DESIGN REVIEW COMMITTEE

May 5, 2016

FROM: NANCY FERBER, PLANNER *Nancy Ferber*

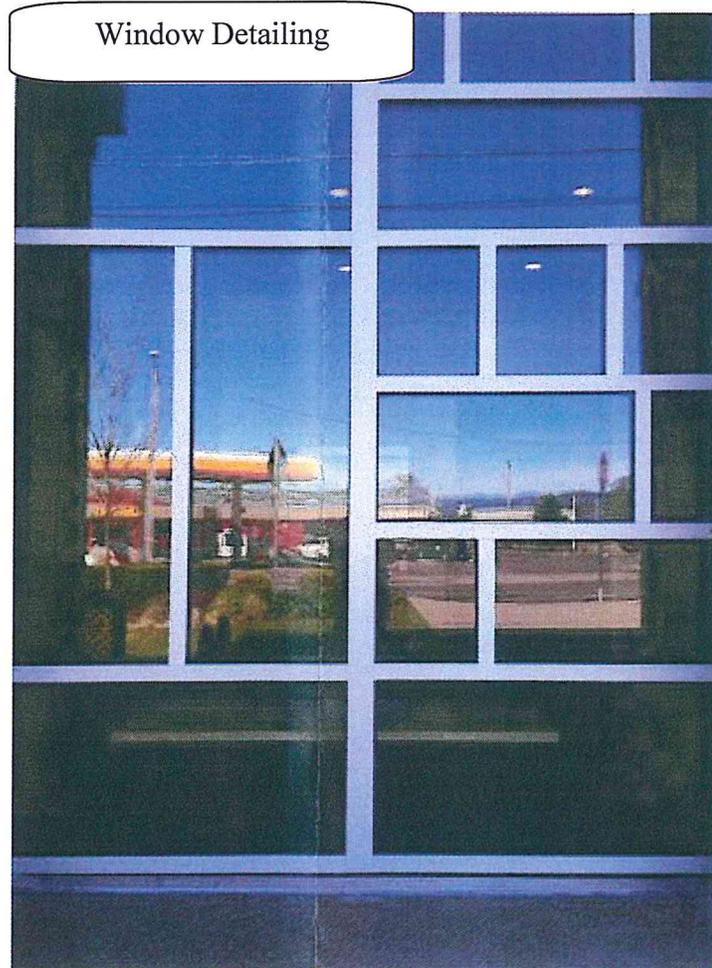
Finding: Proposed windows are true-divided with multiple lites. Most will be aluminum storefront with a possible curtain wall system on the north elevation to provide river views to patients. The large expanse of glazed window intends to bring natural light into the patient care space and provide privacy. Windows shall be spaced and sized so that window area does not exceed wall area.

However if the north frontage is considered as a commercial façade the large window area is allowable.

There are windows on all elevations, there are no blank walls. A concrete wall on the west elevation is required as a barrier for radiation from a linear accelerator machine. There are narrow windows in the adjacent staff entry/exit area.

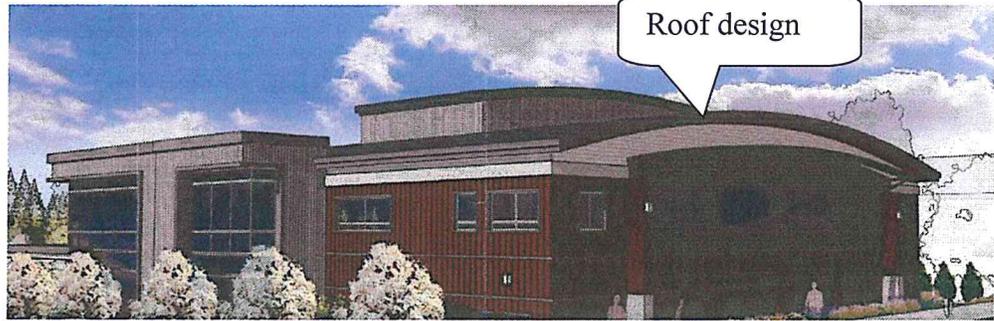
The structure will have low sloped barrel roof, and some

flat roof elements that incorporate a parapet wall. The roof lines are at multiple heights creating visual variation to the roof elements.

The multi-level barrel roofing are not common in Astoria, but can be found nearby in the Pavilion building, as well and the nearby Armory located at 1636 exchange

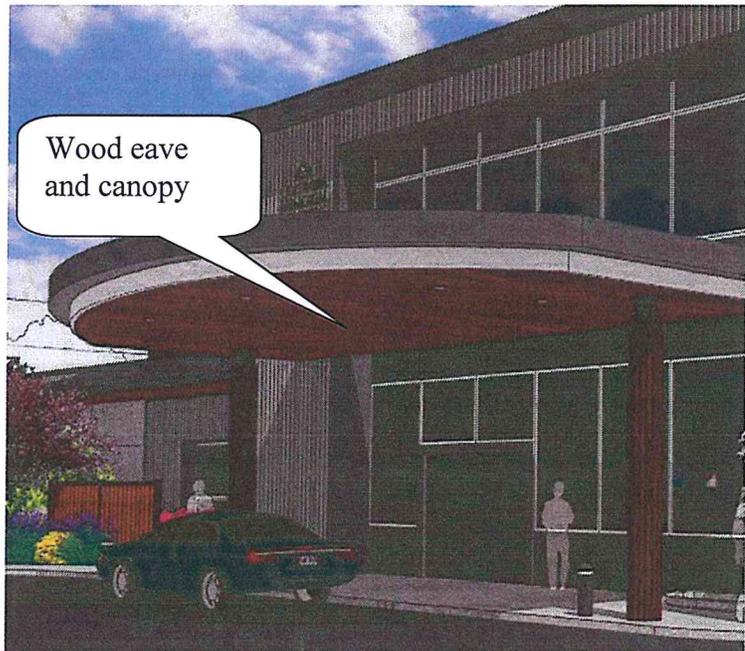
The fixed wooden canopy for rain protection and ease of patient entry is encouraged in commercial buildings. The proposed project will have the large awning at the front entry for patient drop-off, and awning over the entry to the survivorship garden and west staff entry.

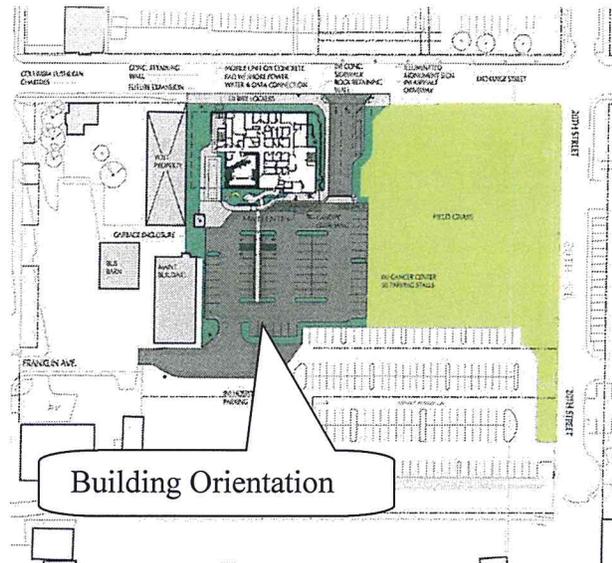
Finding: The proposed project covers multiple lots and a large area of what was previously John Warren football field. The building entrance is on the south side and provides access to the parking lot situated behind the building. The north façade fronts Exchange Street. The building is set close to Exchange Street positioned at the minimum 10' front yard setback. There is no vehicle use between the building face and Exchange Street.

The current design does not promote a pedestrian-oriented street front. The combination of a long front façade of glazed windows, and lack of main entrance does not provide an inviting area for pedestrians.

The design and orientation of the building should take more than just patient access into account. The neighboring areas are zoned for commercial, residential and family activities, all of which draw populations other than just patients to the area. The non-compliance of neighboring buildings is even more reason to provide a welcoming and pedestrian friendly northern façade for this area.
